Site Plan Review Committee (SPRC)
Staff Report for Wells Fargo/Verizon (3140
Washington Blvd. & 1025 N. Irving St.)

Item 1. SPLN22-00002
Wells Fargo/Verizon
(RPC# 19004012; 19004005; 19004011; 19004008)
Planning Commission and County Board meetings to be determined.
Peter Schulz (CPHD Staff)

SPLN22-00002
Wells Fargo/Verizon
(RPC# 19004012; 19004005; 19004011; 19004008)

Figure 6-- Courtesy Applicant

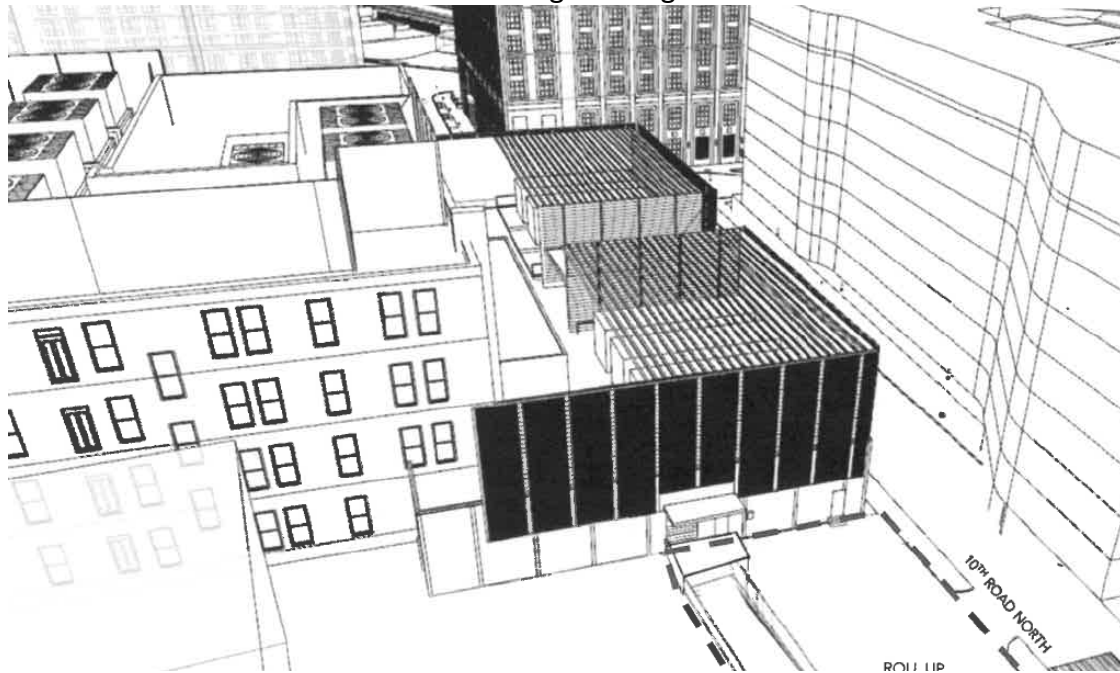
- Architecture/Urban Design: The developer and Verizon propose mechanical screening on the Verizon building. Staff would like to see other aesthetic improvements to the one-story, windowless 1970s Verizon addition.

- Architecture/Urban Design: Mechanical screening needs to be set back an equivalent distance to its height from the edge of the roof.
- Public Space/Landscaping: The proposed 10th Road North streetscape does not comply with the Zoning Ordinance requirements and good urban design practice—there are no street trees, an inconsistent sidewalk width, and sidewalk “jogging” created by the desire for the drive through ATM.

Verizon Building: The existing building, built over the course of decades since the 1930s, has some historic and aesthetic value, especially in the main four-story building block. While the building will remain, the developer and Verizon plan to work together to screen the existing emergency generators on the one-story 1970s façade. (Verizon also has plans to add rooftop mechanical equipment in the future and propose to screen them similarly.) Staff also has been encouraging the parties to examine improving the architecture of the windowless 1970s addition.

Figure 8-- 10th Road civil Plans

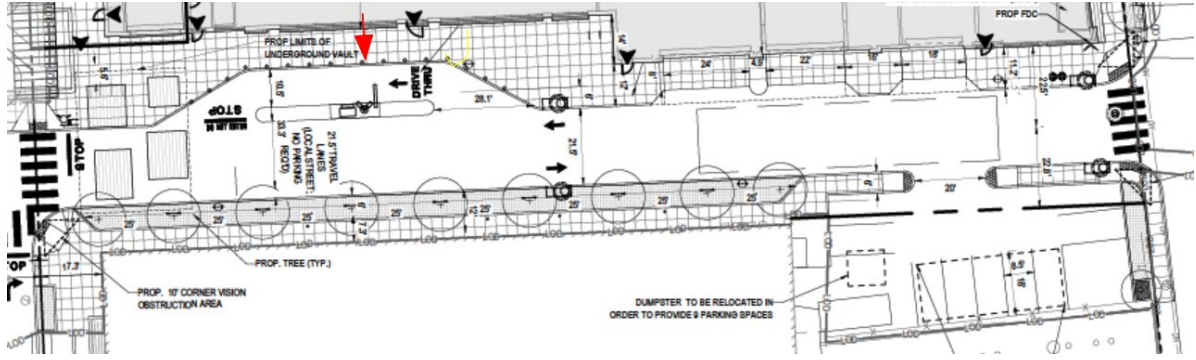
- Transportation: The presence of the drive-through creates a sub-optimal experience for pedestrians on the North Side of 10th Road, including lack of street trees and a jog in the path.

- Transportation: The Sector Plan envisions 10th Road as a local street with parking on at least one side of the street. Currently 10th Road looks more like an alley.

Streetscapes: ACZO Section 9.2 has detailed streetscape requirements for all frontages (see Section 9.2.3 Table 1 and Section 9.2.9 Map 5). The developer is generally compliant with the streetscape requirements, except for 10th Road North. The Zoning Ordinance requires a 12 foot sidewalk, with a six foot clear zone. Street trees are to be planted in minimum 5' X 12' tree pits, spaced approximately 30' on center (subject to adjustments for light pole location). The developer does not meet these requirements on either side of 10th Road North. On the south side, it is generally because of the desire to keep surface parking for Verizon, on the north side, it is caused by Wells Fargo's desire for a drive through ATM. On both sides of 10th Road, the sidewalk "jogs" in order to accommodate these desired uses. Jogs are generally discouraged in more urban public sidewalks, although 10th Street will generally be a less travelled street by pedestrians than the other surrounding frontages.

Figure 9-- Irving Street stepback

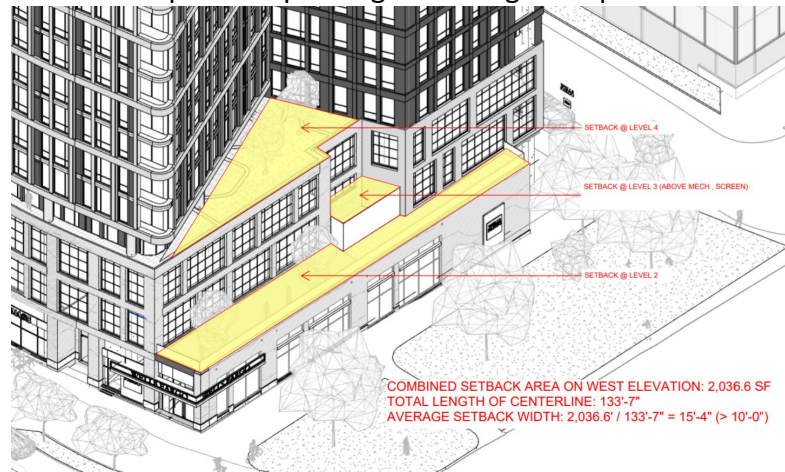
Stepback: One building stepback of 10 feet is required on Irving Street on the on the second, third, fourth or fifth floor. The developer is requesting an averaged stepback as shown below:
